Woden Village DA RFI – List of Changes:

SECTION B-B

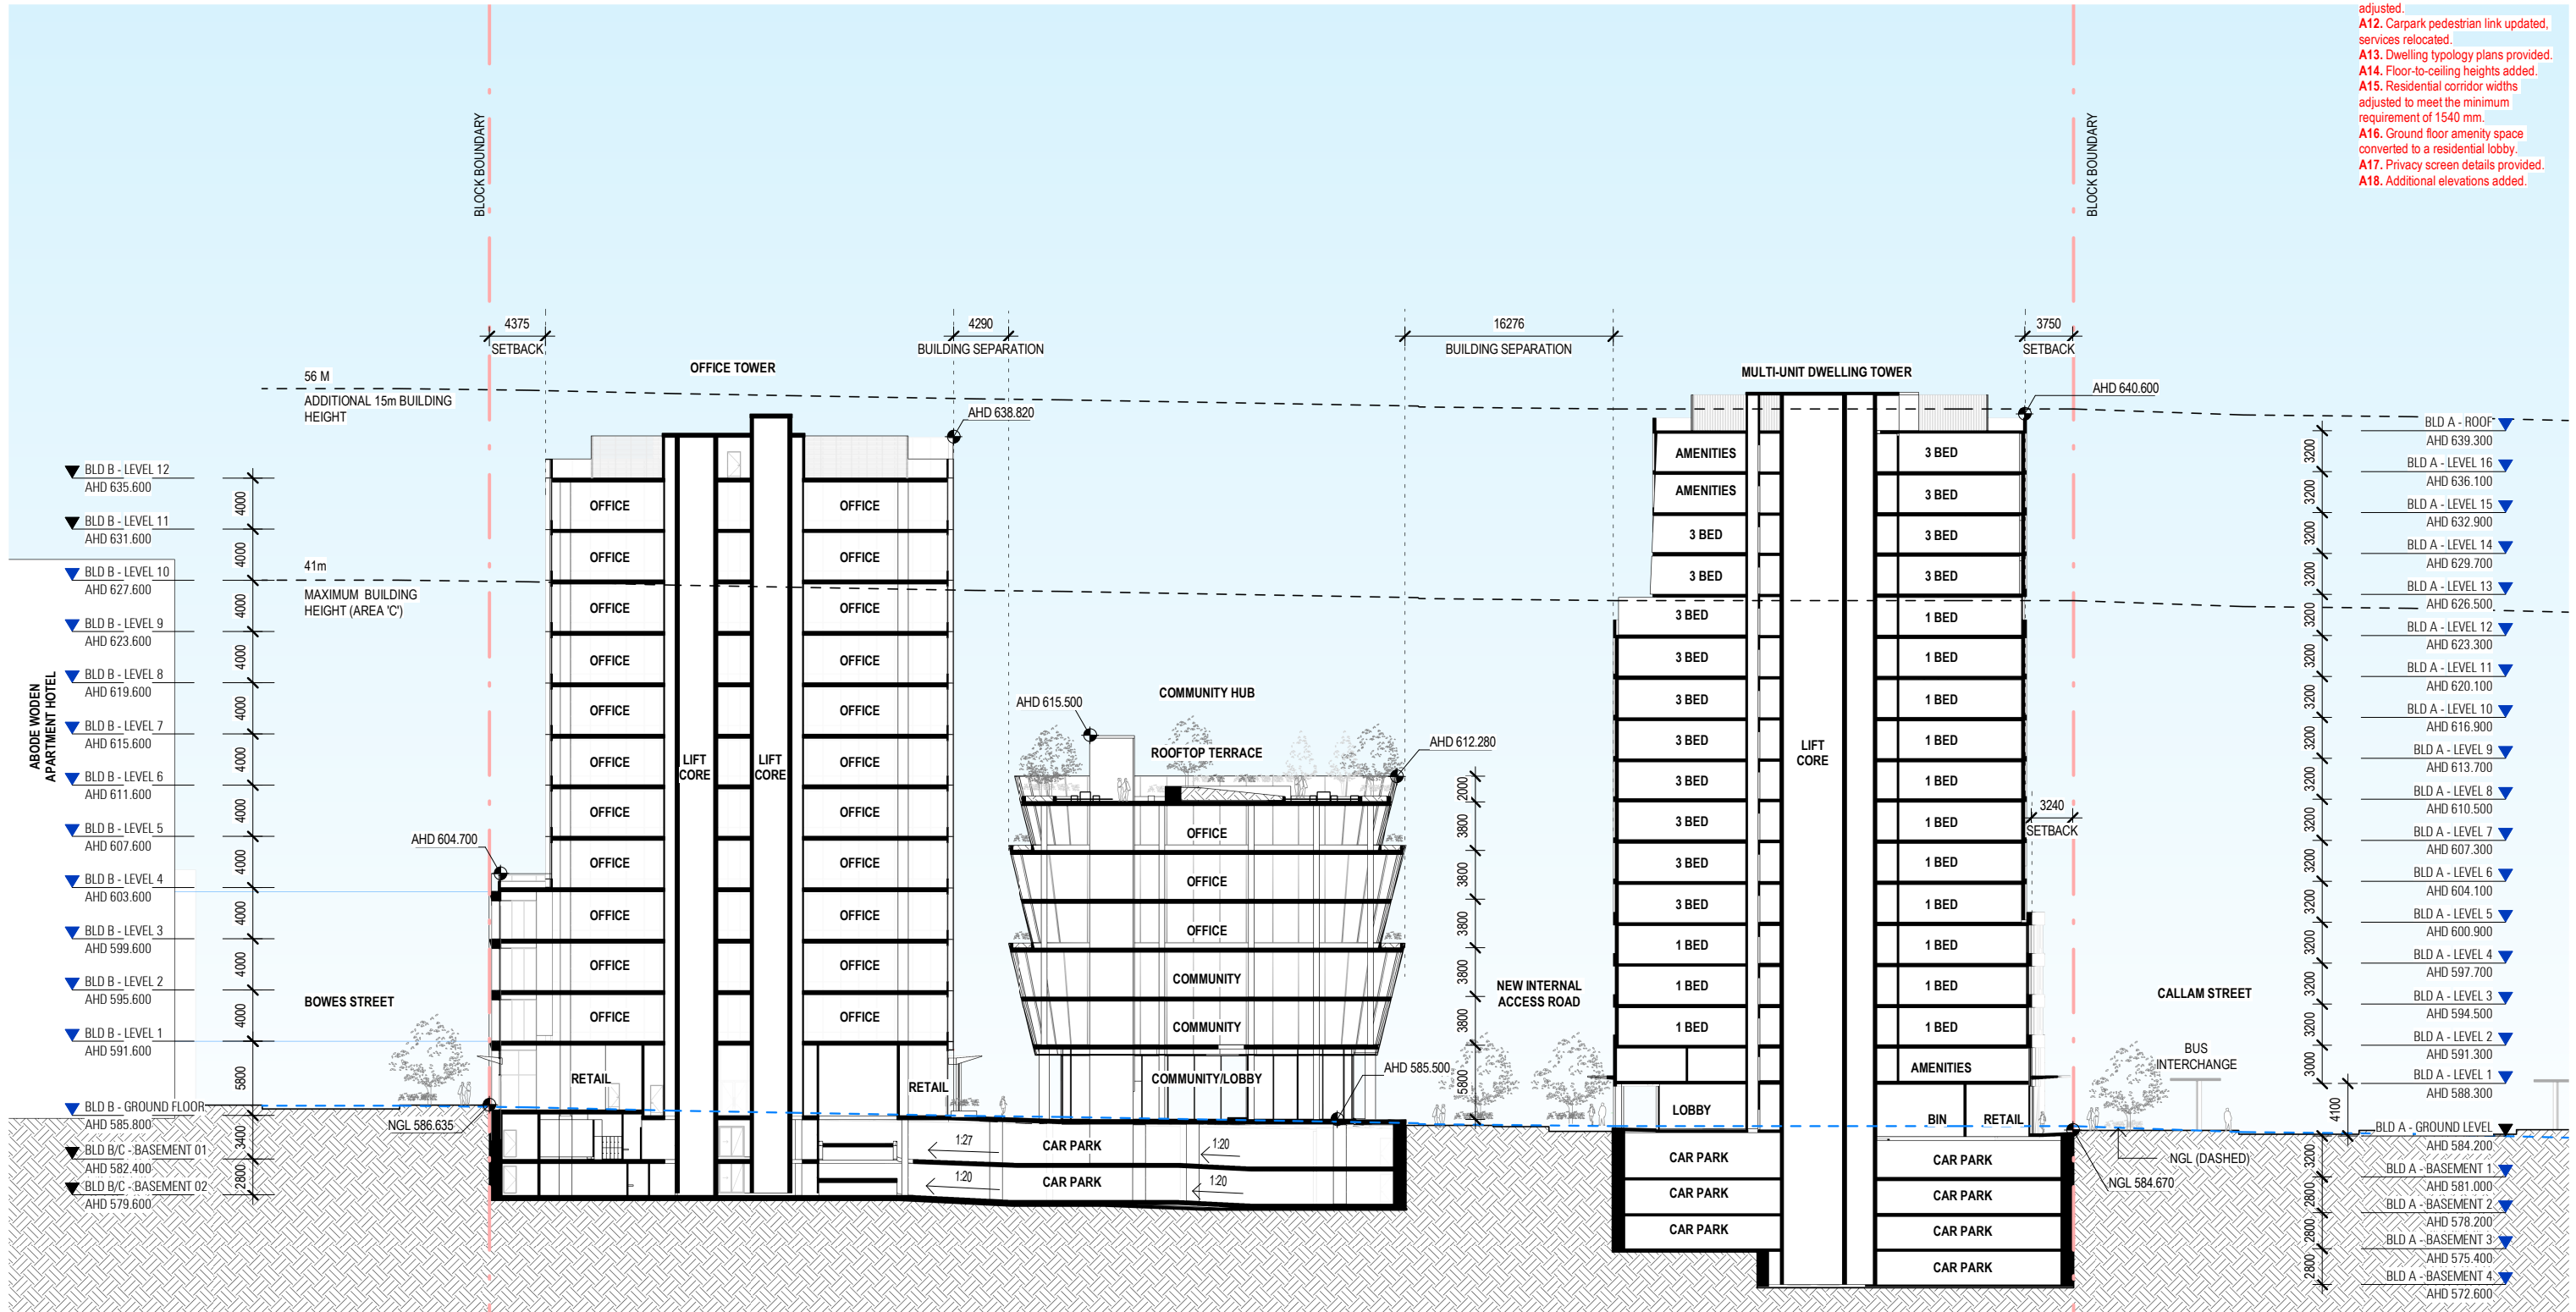
- A1. Driveways and verge crossings updated to match the Waste Management Ground Floor Plan.
- A2. Ground floor waste enclosures and waste storage updated.

- A3. Canopy above the waste collection zone removed.
- A4. Carpark link design revised.
- A5. Residential building link height adjusted.
- A6. Apartment layouts revised to improve functionality.

- A7. Development Schedule for the Community Building revised.
- A9. Northern Residential Tower upper levels revised (façade, internal planning, and apartment mix updated).

- A10. Carpark roof landscape updated.
- A11. Roof plant area setbacks updated, and solar panel orientation adjusted.
- A12. Carpark pedestrian link updated, services relocated.

- A13. Dwelling typology plans provided.
- A14. Floor-to-ceiling heights added.
- A15. Residential corridor widths adjusted to meet the minimum requirement of 1540 mm.

- A16. Ground floor amenity space converted to a residential lobby.
- A17. Privacy screen details provided.
- A18. Additional elevations added.
